Dimming Ballasts

Comments regarding draft regulations:
Dimming Ballasts

Docket # 14-AAER-1

June 6, 2014

Figure 1. I-BLE as a function of full output lamp arc power.

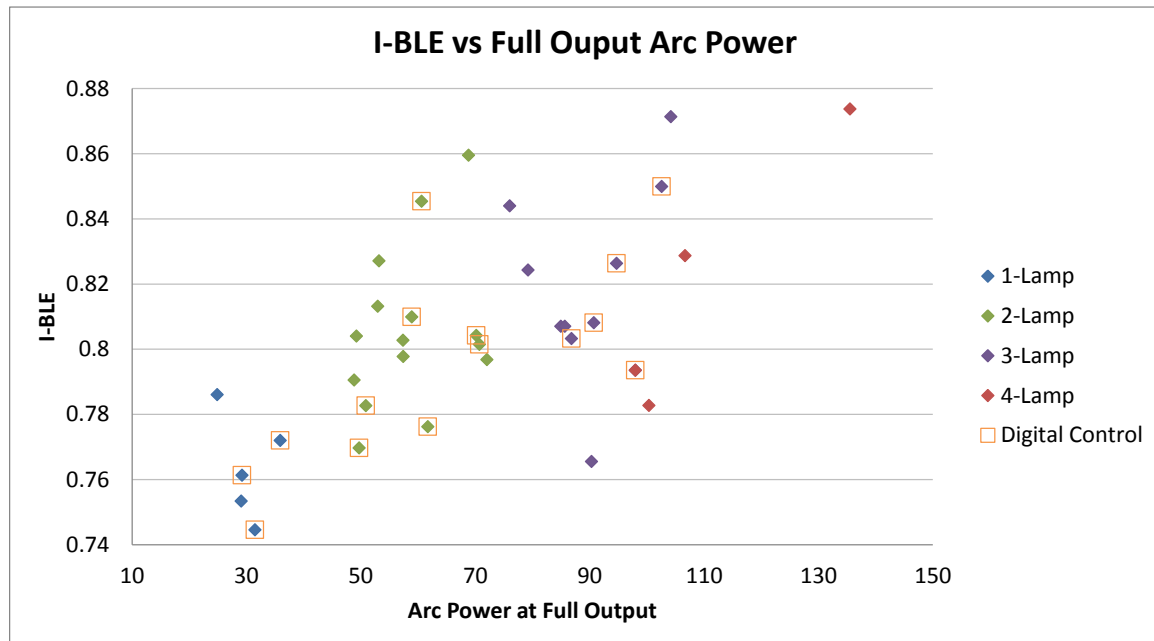
Southern California Edison (SCE) conducted extensive testing of 34 unique dimming ballast models to measure BLE throughout the dimming range. This test dataset was used by both the CA IOUs and CEC to develop proposed standard levels. A plot of I-BLE as a function of full output lamp arc power for the ballasts tested by SCE is provided in Figure 1 below. Ballasts are color coded according to the number of lamps they operate. Digitally controlled ballasts are marked with orange squares.

I-BLE is a more effective method for representing dimming ballast efficiency than annual energy use. I-BLE allows for an easier comparison between the efficiencies of different products, particularly when evaluating efficiencies of ballasts with very different ballast factors, or across ballasts designed to operate different numbers of lamps. I-BLE would therefore be a more useful metric for lighting specifiers and for building energy modelers, particularly when the components

Figure 2 below plots the proposed standard level against the I-BLEs of all ballasts in the test dataset.

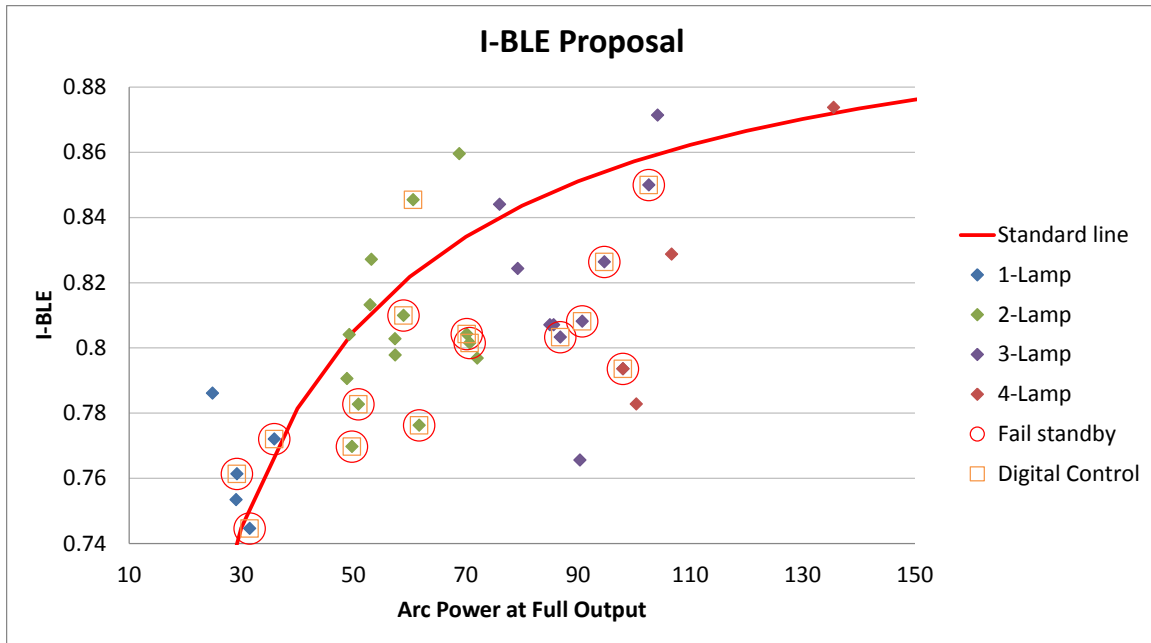
The proposed I-BLE-based standard is presented below:

$$I \cdot BLE \geq \frac{AP_{Full\ Output}}{AP_{Full\ Output} * 1.091 + 7.55}$$

$$AND\ standby\ mode\ power \leq 0.5\ W.$$

Figure 3. Range of cathode heating to maintain safe operation of fluorescent

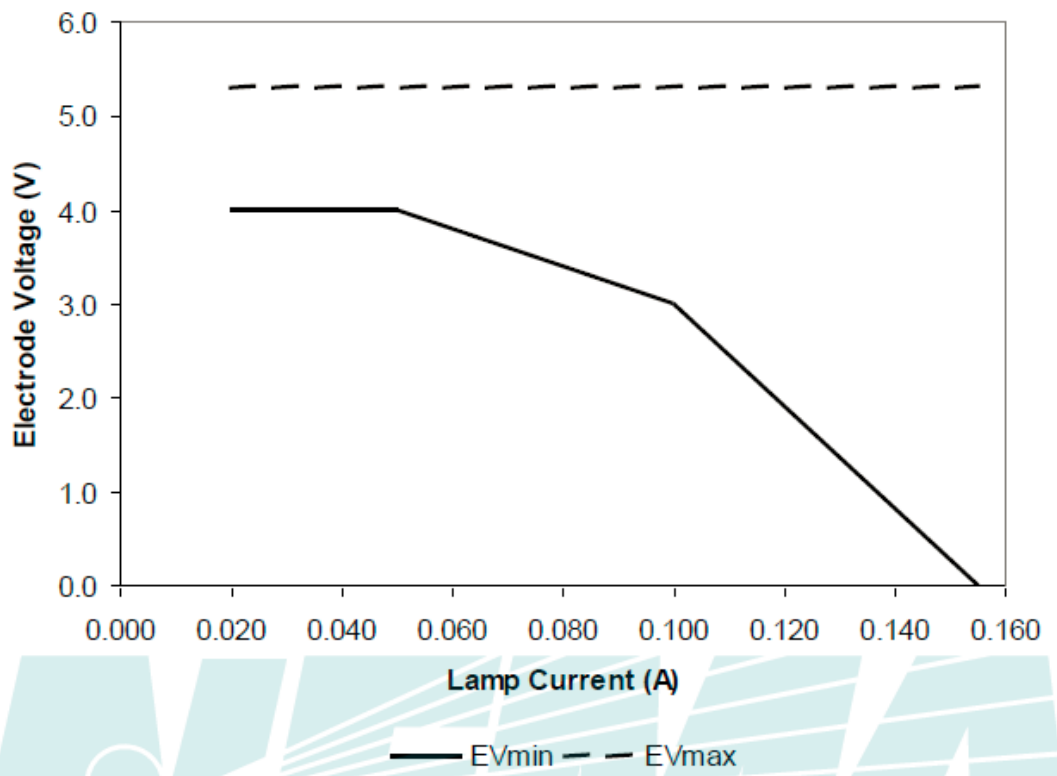
Figure 3 presents the minimum and maximum electrode voltages that the ballast is required to supply for maintaining safe lamp operation, as a direct function of lamp arc current.

The dotted line represents the maximum voltage at 5.3V. This can be translated to power using the formula:

We have conservatively chosen 10 Ohms to develop an estimate of maximum power required for cathode heating.

This results in a maximum power allowance of 2.8 W per cathode (or 5.6 W per lamp). This maximum amount of cathode heating power that should not be exceeded does not change throughout the full range of lamp arc currents; however, the amount of current that must be minimally provided, as defined by the solid black line, does change. As shown in Figure 3, above 155 mA of lamp arc current, zero cathode heating is required; as the lamp arc current drops below 155 mA, steadily more power for cathode heating is required. The difference between the maximum and minimum amount of cathode heating that could be used at a given lamp arc current, as defined in LL-9, represents the range of possible efficiencies that can be achieved by improving control of cathode heating. At 155 mA and above, this is a difference of up to 5.6 W per lamp, between ballasts that provide the minimum required versus maximum recommended heating to the lamp cathodes.

In the IOU test dataset, all ballasts operated lamps at significantly higher than 155 mA of lamp arc current at full output, suggesting that all ballasts, when set to 100% output, are able to safely operate the lamp without providing any supplemental cathode heating. When dimming, for most lamp-ballast test runs, the lamp arc current typically did not drop below 155 mA until the lamp arc power dipped to around 70% of the maximum full output arc power. All of these ballasts would be able to eliminate cathode heating and improve ballast efficiency at both the 100% and 80% arc power measurements.

Improved control of cathode heating at lamp arc currents above 155 mA is a significant energy savings opportunity. As previously mentioned, LL-9 shows that the difference between the most efficient and least efficient ballasts (in terms of cathode heating control) can be up to 5.6 W of power per lamp. This represents over 17% of the total power needed by a standard 32 W lamp at full output. The standards proposed by CEC, as well as the IOU proposal, will generate significant energy savings by effectively requiring high ballast efficiencies at 100% and 80% full output, where most dimming ballasts have the opportunity to drastically reduce the amount of heating provided to the lamp cathodes while remaining in the LL-9-defined zone of safe operation. The proposed standards can generally be met more easily by ballasts that utilize better control over cathode heating.
